# UNITED STATES PATENT AND TRADEMARK OFFICE

APPLICATION NO.	FILING DATE	FIRST NAMED INVENTOR	ATTORNEY DOCKET NO.	CONFIRMATION NO.
10/064,326	07/02/2002	Georg K. Blaschke	20044	8283
23470	7590	12/06/2005	EXAMINER	
SRAM CORPORATION			KIM, CHONG HWA	
1333 N. KINGSBURY, 4TH FLOOR			ART UNIT	PAPER NUMBER
CHICAGO, IL 60622			3682

**Office Action Summary**

App'l. No. 10/064,326  
New Sheet

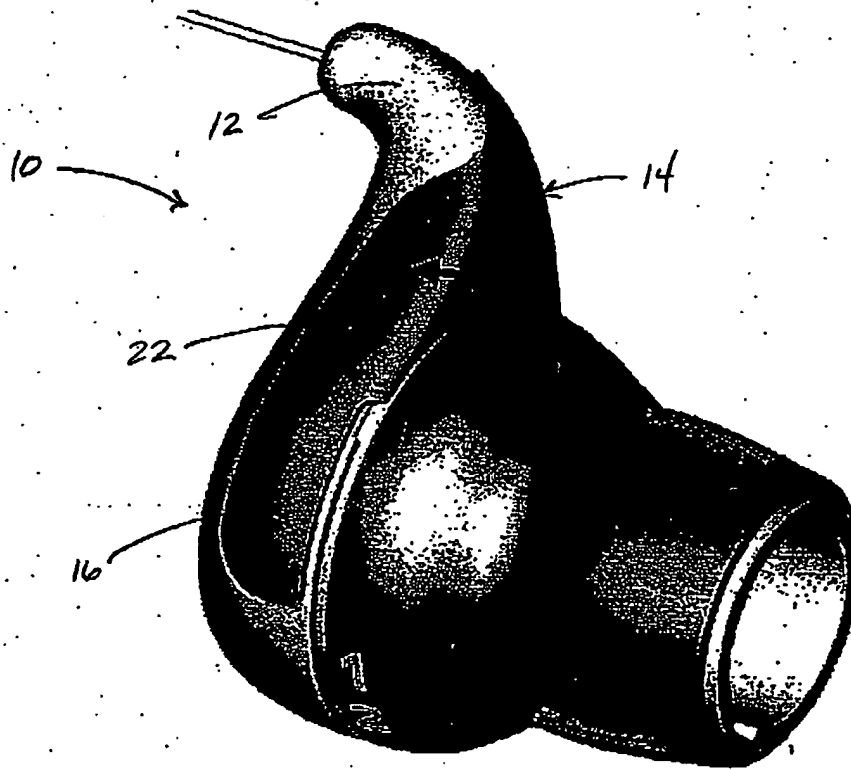
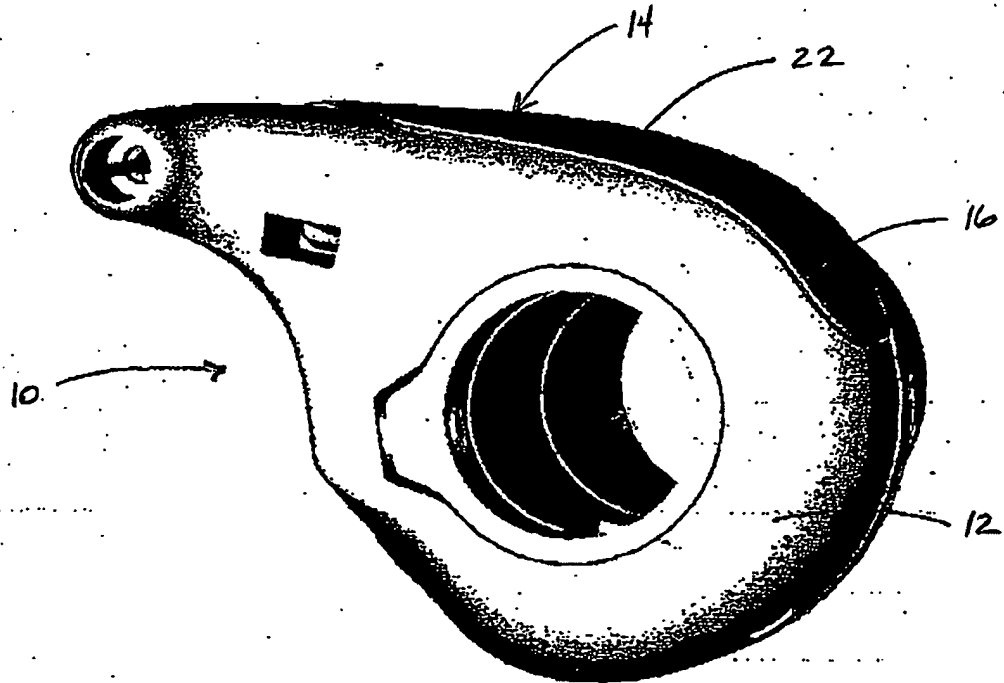
1. The amendment filed Sep 15, 2005 is objected to under 35 U.S.C. 132(a) because it introduces new matter into the disclosure. 35 U.S.C. 132(a) states that no amendment shall introduce new matter into the disclosure of the invention. The added material which is not supported by the original disclosure is as follows: Figs. 2 and 3 and the specification as amended including the subject matter of the second housing element and its attributes.

Applicant is required to cancel the new matter in the reply to this Office Action.

not approved on 11/30/05
